File No: 2013/127486
Our Ref : R/2011/5/1
Your Ref: MP 11_0001

RE: Sydney Heritage Fleet, 5-7 Bank Street, Pyrmont

The City provides its comments in relation to the proposed new building associated with the Sydney Heritage Fleet that includes small vessel storage, amenities, community-based maritime skills centre, museum display, community space, exhibition pavilion, kiosk and a fixed wharf.

Figure 1: Proposed Bank Street façade.

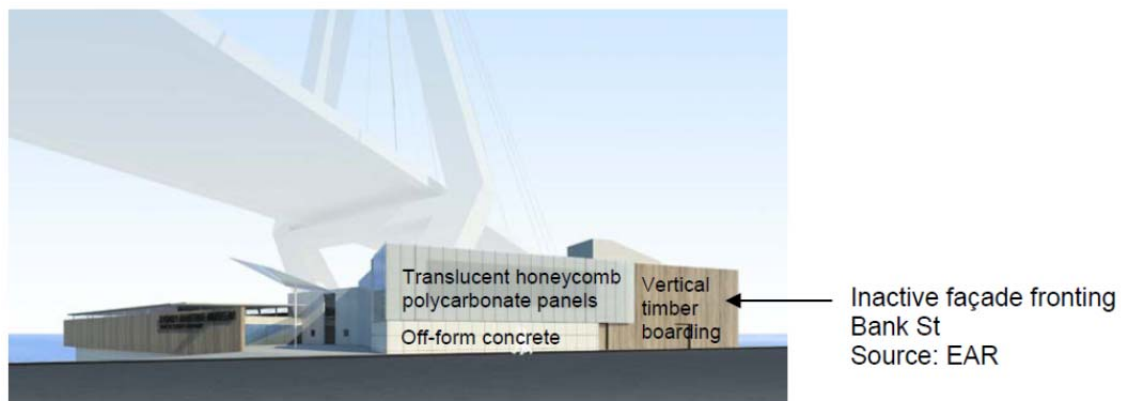
The activities fronting Bank Street are primarily associated with services and utilities such as delivery areas, fire stairwell, lift, store rooms and rubbish bin storage area. Although a degree of façade articulation is achieved through the use of different materials and small projections, the Bank Street elevation is inactive and does not provide opportunities for passive surveillance over the public domain. The blank walls appear like the rear of a development with two doors one of which is a fire escape. The building does not address the street well. Additionally, there is also an inactive façade on the eastern elevation adjacent to the future park. It is recommended that the proposal be amended to improve the activation to the street and park.

Figure 3: Proposed building layout.

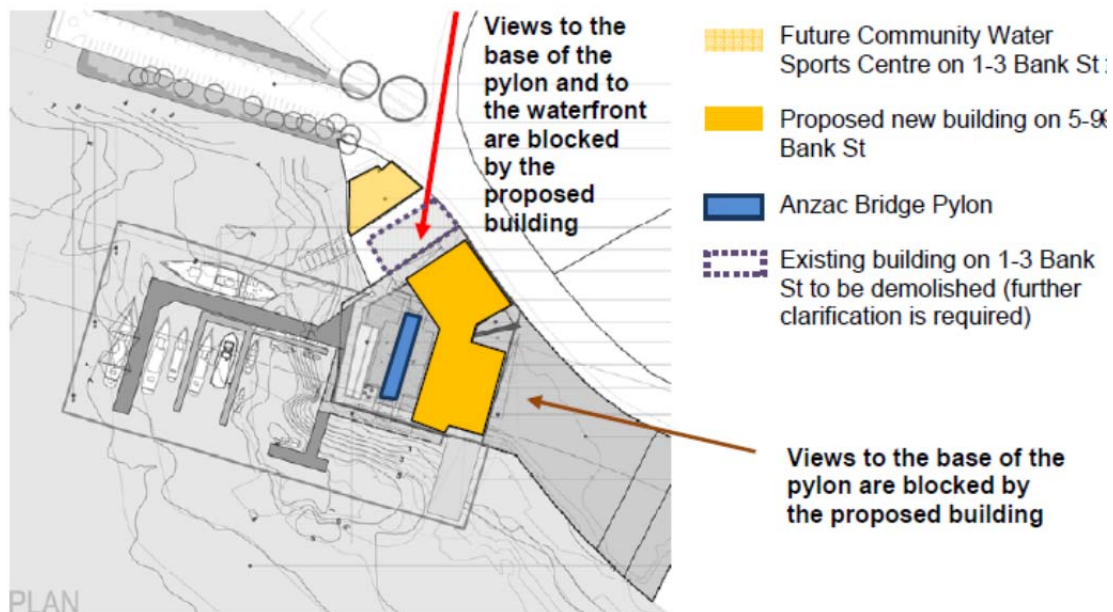
The proposed site planning takes little consideration of the structure of Anzac Bridge and the nearby prominent viewlines. The building wraps around the pylons and blocks views to the base of the structure and to the waterfront.

Figure 4: Site Planning recommendation

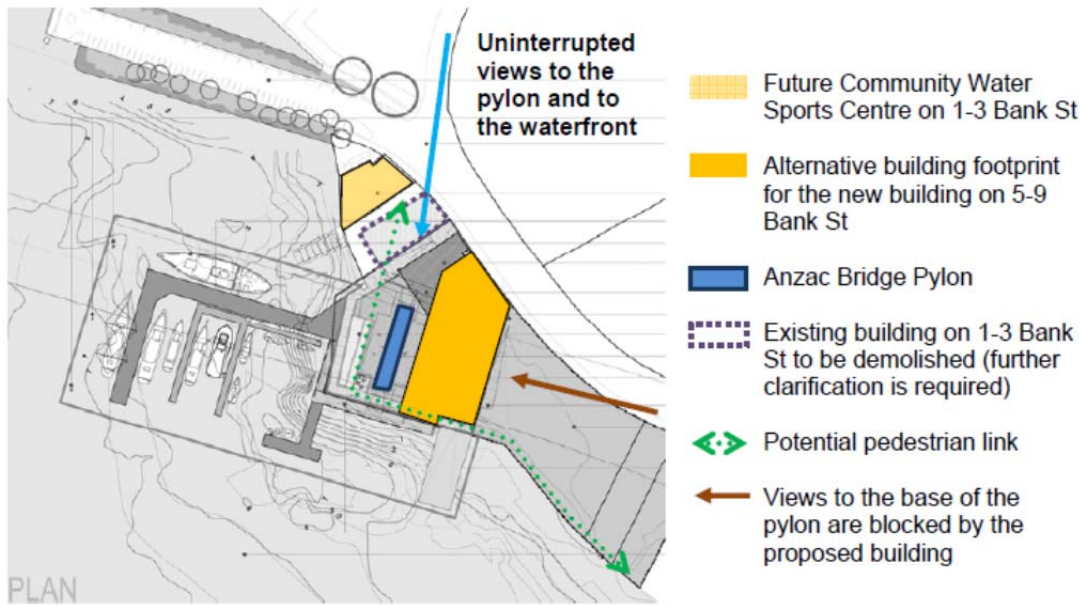
There is an opportunity for the proposal to enhance its relationship with Anzac Bridge and the waterfront, and to improve pedestrian connectivity, by placing the building in a way that enables uninterrupted views from Bowman Street towards the base of the pylon and the water beyond. This design solution could also create a direct pedestrian link from Bowman Street down towards the water. This will be made possible by the future development of the neighbouring site at 1-3 Bank Street for the proposed future community water sports centre.
